SOILS EVALUATION

Record Number: EHU-07-25-0675

This soils evaluation is intended for Large Lot subdivision China Garden View Estates.
The proposed lot number is 15 of 45.

Site Evaluation & Soil Report for Lot 15 @ Parcel Number: 411840113

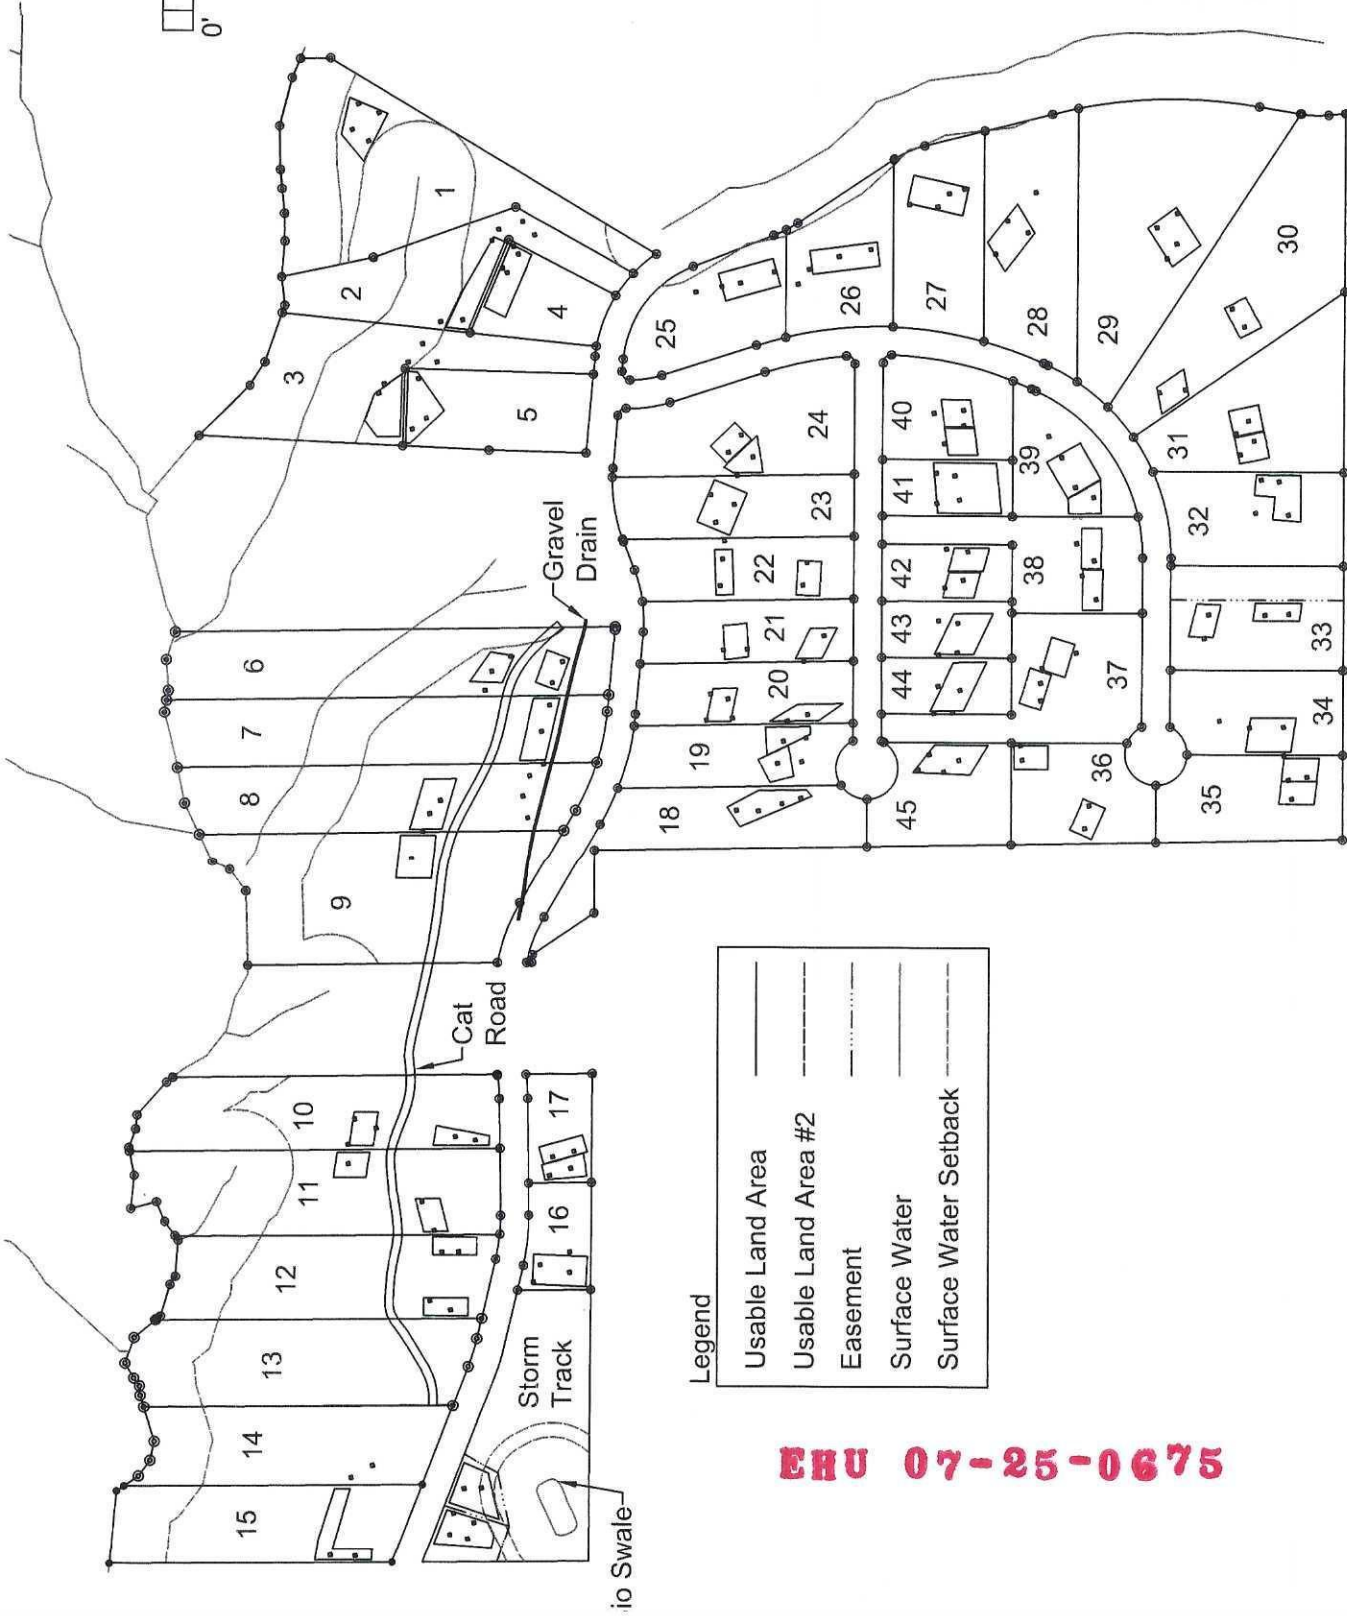
This site appears to be able to, at this time, support an OSS as proposed.

Approved Soil and Site evaluations are valid for five (5) years from the approval date. The proposed septic primary and reserve area(s) set-aside for future septic use must be protected from grading, fill, compaction, or any other alteration that may change soil characteristics. Soil and Site evaluations may be invalidated if the proposed septic area(s) are not protected.

For future well construction: When drilled, the well must maintain a 100’ setback from the approved, proposed primary and reserve septic areas or new test holes will need to be opened and evaluated.
